## Scope

Some breaks of the power supply in the PT5664/50 have shown to be caused by a high tension capacitor, not living up the usual quality.

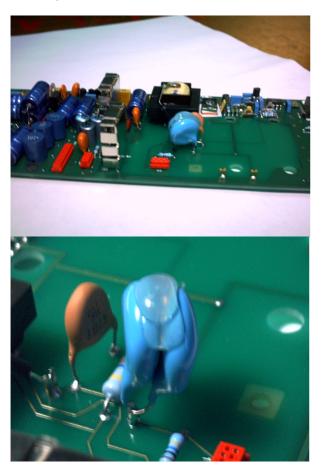
Capacitor C-063 (10nF) to be changed to 2 pcs. 4,7nF, make: MuRata: DE1610-452E472M-KXSMKX12C50 Both capacitors to be mounted as shown below:

A pair of Zenerdiodes BZX79-12V is mounted on the solder side of the PCB in an antiparallel mode.

Please refer to diagram and picture below:
